# City of South Bend PLAN COMMISSION

## AGENDA

**Monday, March 16, 2020 - 4:00 P.M.**

- 1) **Location:** North side of Adams Road along Dillon Drive PC#0008-20  
**Name:** PORTAGE PRAIRIE BUSINESS PARK - PRIMARY PLAT

Proposed Site Plan

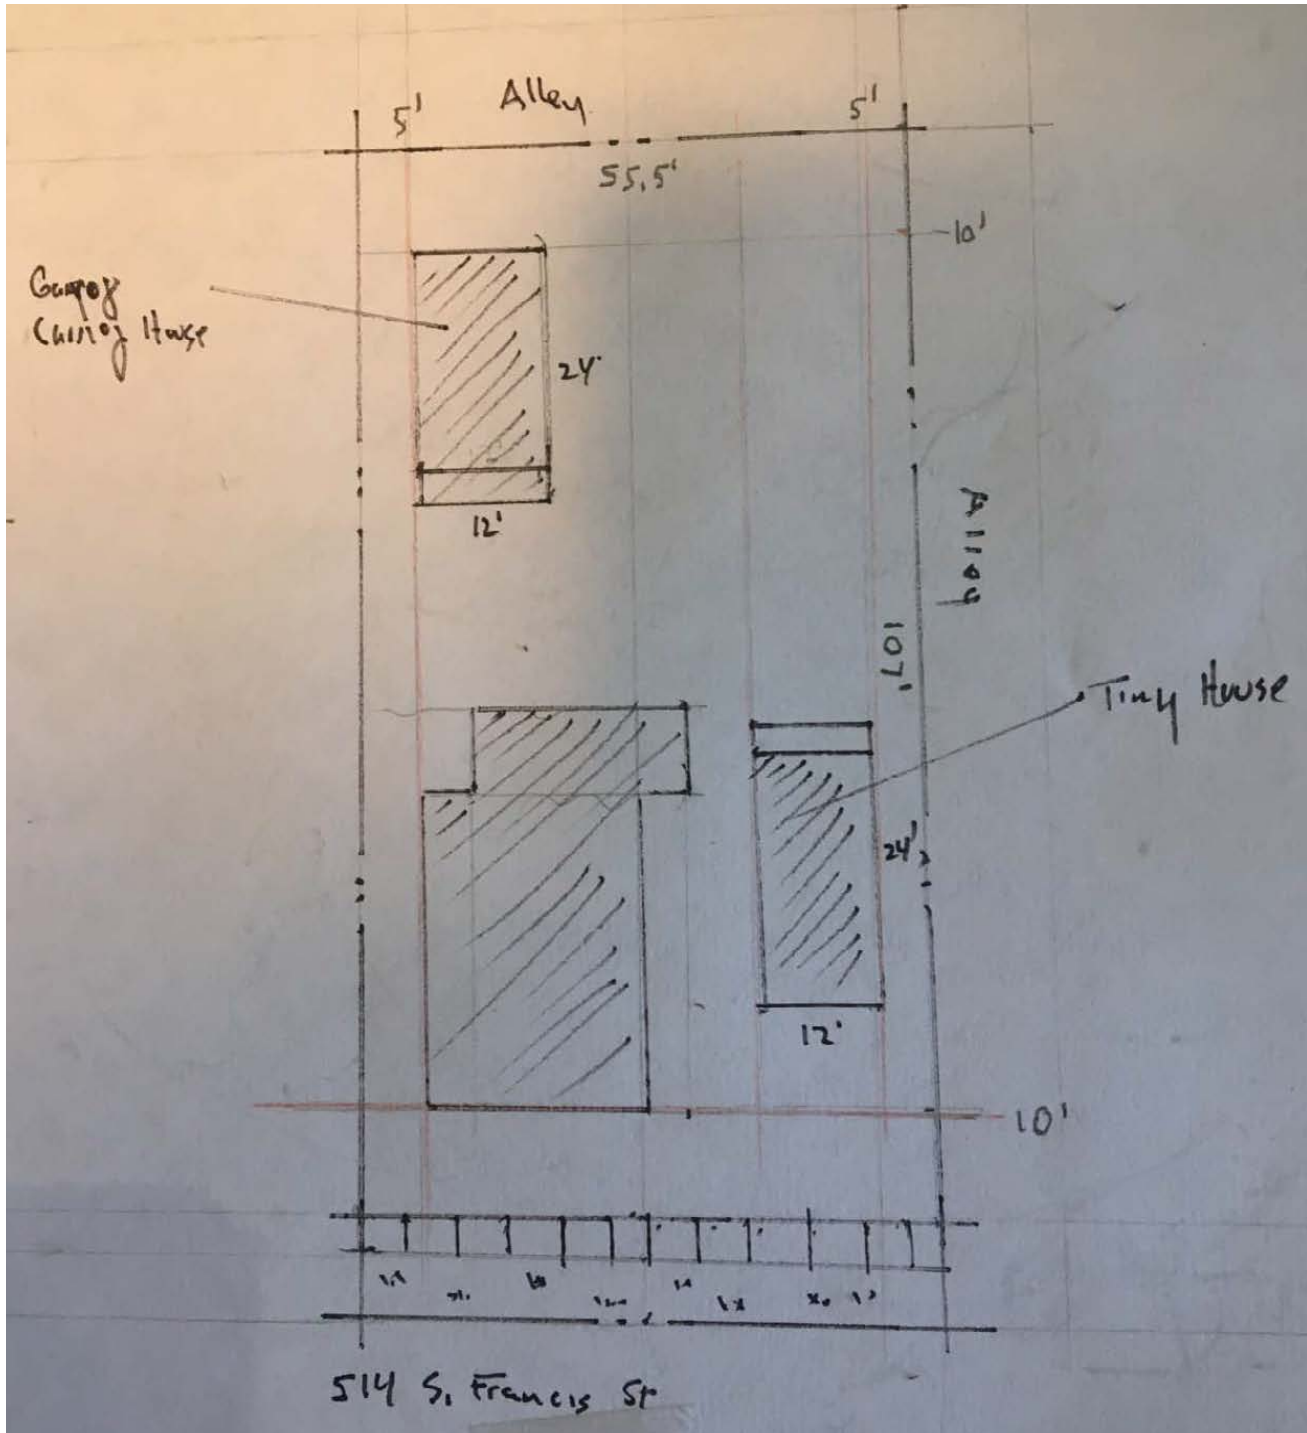
The site plan as submitted shows the construction of a detached "tiny house" to the south of the current house and a "Garage Carriage House" to the east of the current house. The house to south will require a subdivision prior to design and installation. The carriage house will be designed to meet the current development standards of the district.

Zoning of properties to U2 Urban Neighborhood 2 allows for the creation of more diverse and affordable housing types. These housing types blend well with the character and scale of existing urban neighborhoods. With its location in a walkable neighborhood that is close to downtown, amenities, and transit, and that already has a wide variety of housing types, this property is well suited for U2 zoning.

**Recommendation:** Based on information available prior to the public hearing, the staff recommends the Plan Commission send the rezoning petition to the Common Council with a favorable recommendation.

PORTAGE PRAIRIE BUSINESS PARK  
PRIMARY PLAT

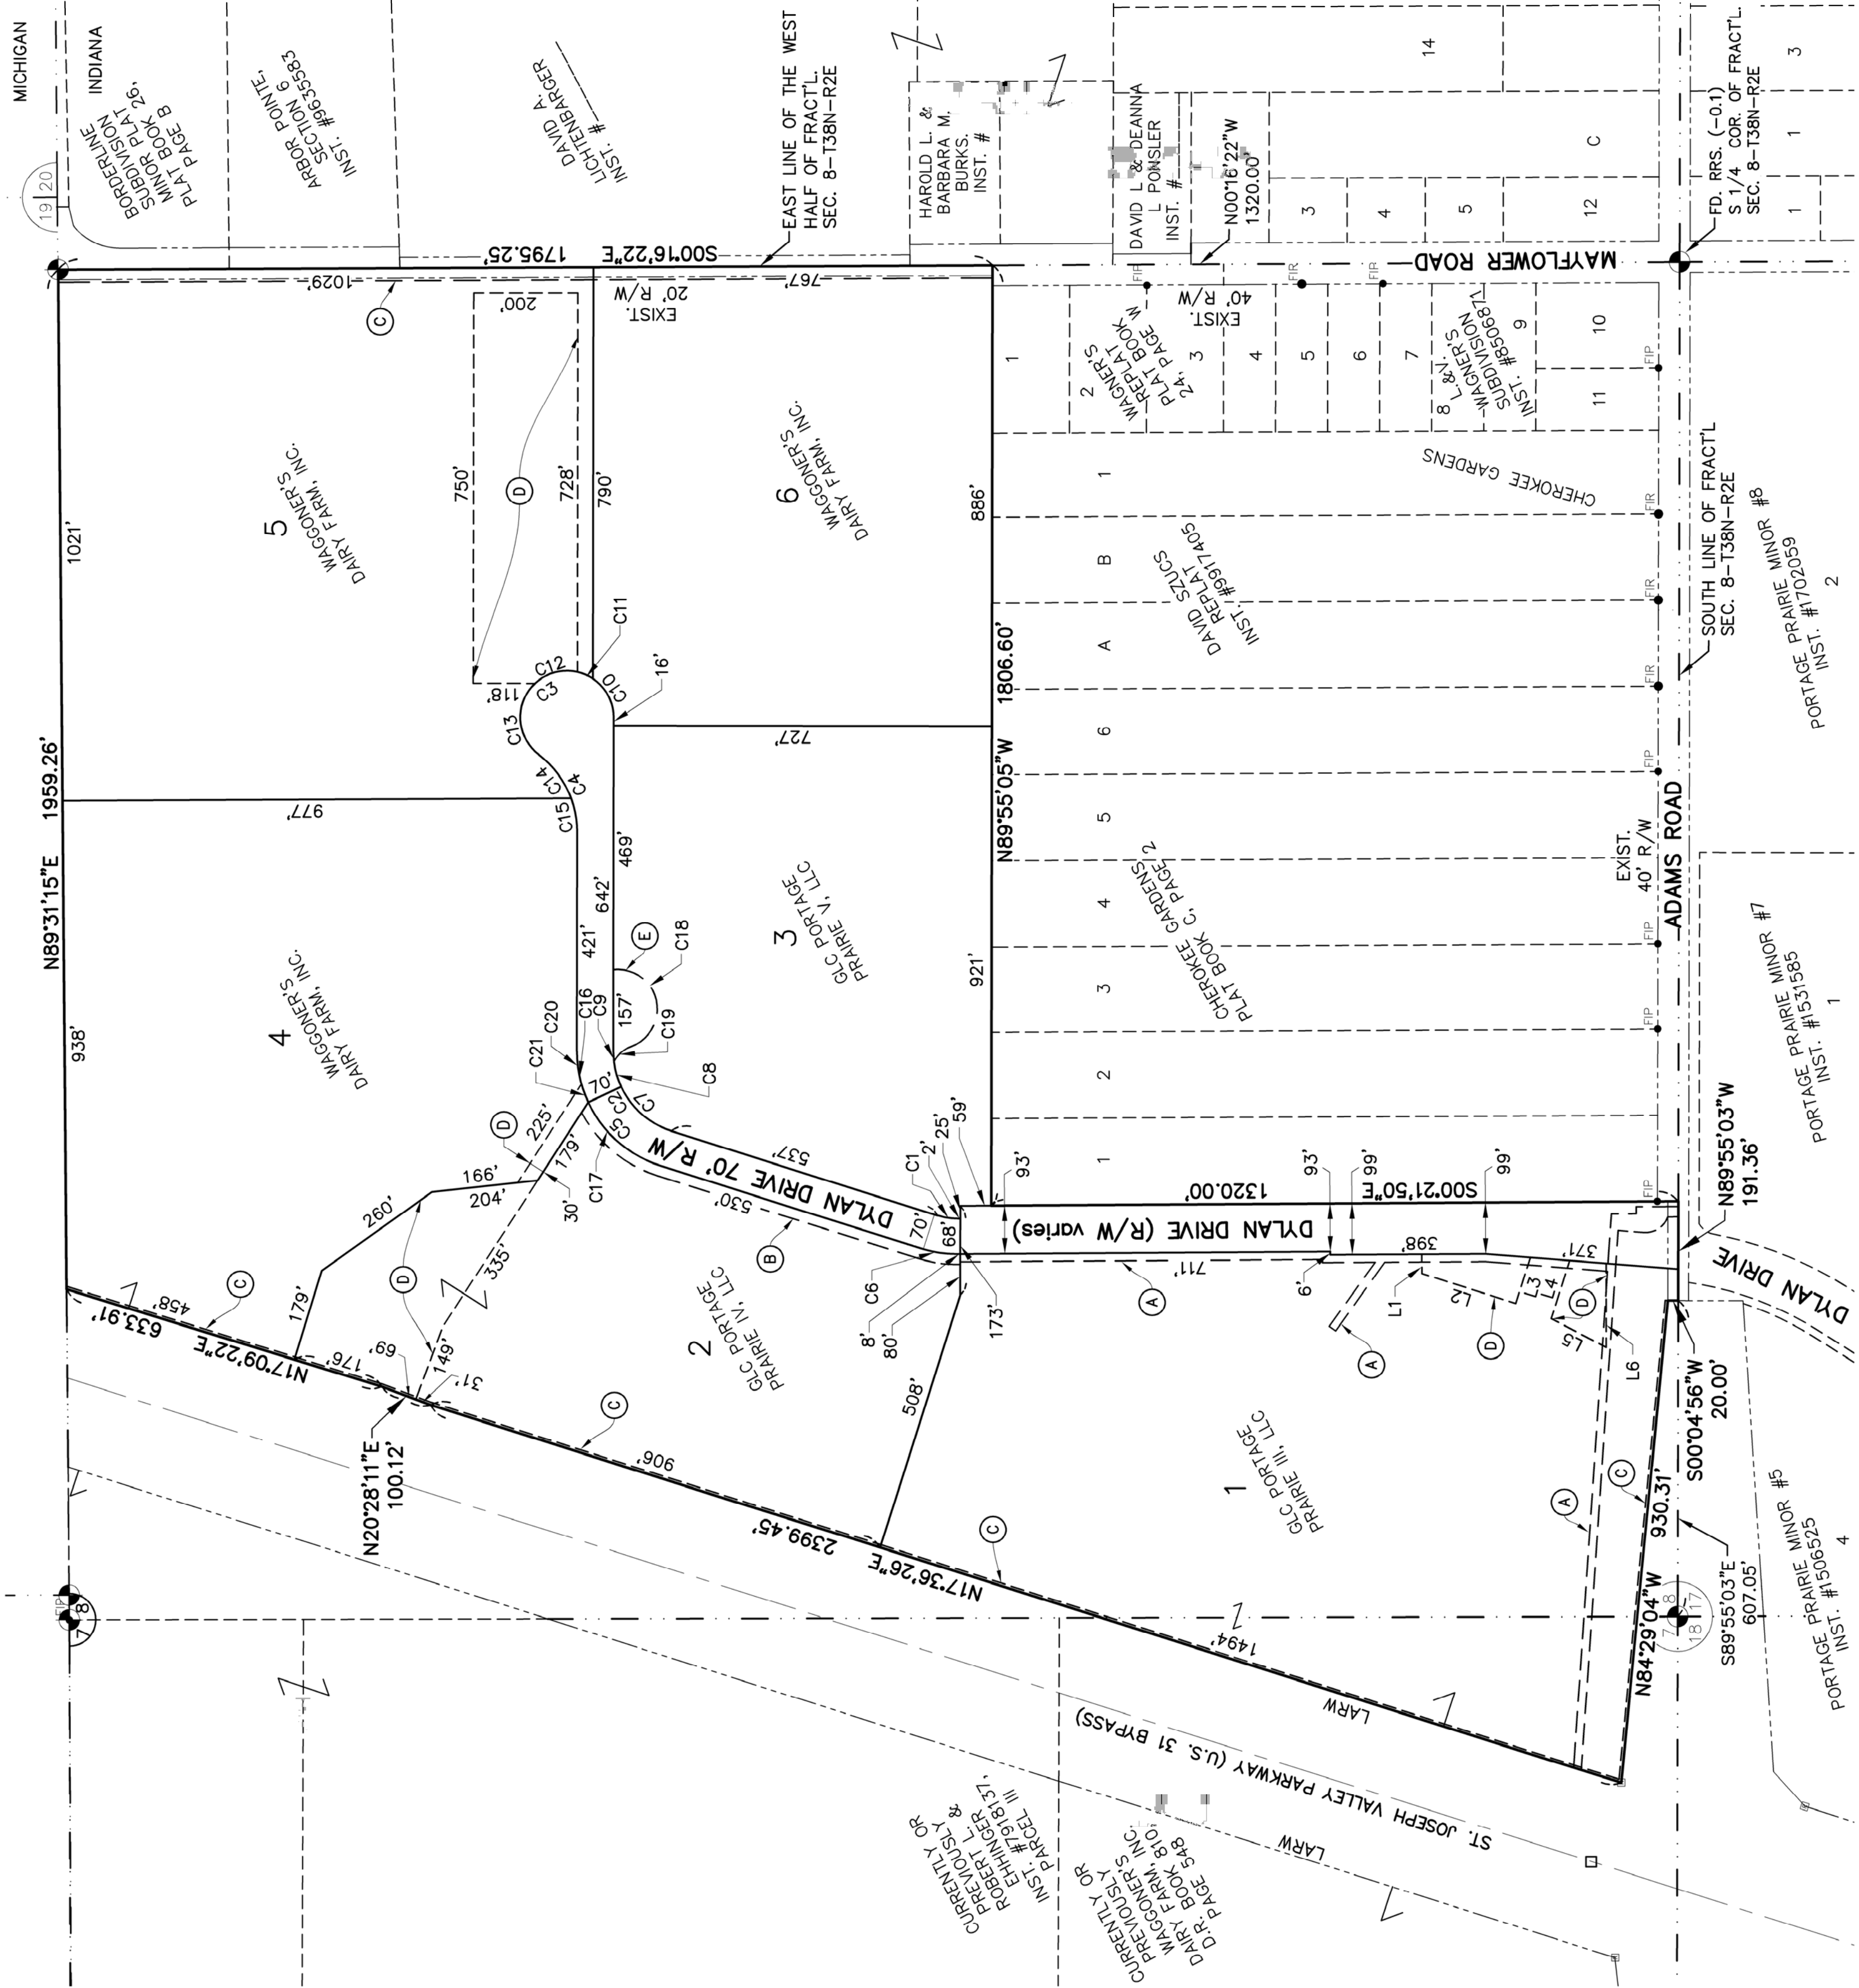
<b>Environmental Data:</b>	A check of the Agency's maps indicates that no environmental hazard areas or wetlands are present.
<b>Drainage:</b>	The conceptual drainage plan has been approved.
<b>Rights-Of-Way:</b>	The rights-of-way are correct as shown.
<b>Utilities:</b>	The site will be served by Municipal Water and Municipal Sewer.
<b>Agency Comments:</b>	The City Engineering Department recommends approval subject to the following: 1) Municipal easement is required between P2, 3 to maintain City storm infrastructure and end section that will drain Dylan to the basin, 30' is desirable. ; 2) Verify that the future Dylan R/W width captures all existing infrastructure and appropriate space given to allow maintenance. It looks like an existing MH is close to the line where the Dylan R/W reduces in width to 68'; 3) Provide a utility plan showing the public extensions along Dylan to the end of the cul-de-sac and indicate how they will serve future development, grades, pressures, etc; 4) Provide roadway data or plans showing the road widths proposed, roadway geometry, cul-de-sac radii, etc. We want to verify roadway will be built to city standards and captured in current R/W; and 5) Remove the space capturing trees on the east side of the sidewalk along Dylan Dr. from City R/W

**Staff Comments:** The petitioner is requesting the following waivers: 1) From Section 21-11.02(d)(5) to install a sidewalk on one side of the public street; 2) From Section 21-11.02(e)(2) to allow a subdivision without 10% public open space requirement; 3) from 21-11.04(b)(6) to allow a 2,924' cul-de-sac.

**Staff Recommendation:** The Staff recommends the Commission approve the waivers.

The Staff has reviewed this subdivision and finds that if the waivers are granted and the conditions are met, it complies with the requirements for Primary Approval as specified by the South Bend Subdivision Control Ordinance. The Staff therefore recommends that this subdivision be granted Primary Approval, subject to the following: 1) Adding the waiver note to the plat; and 2) Addressing the comments from the City Engineering Department.
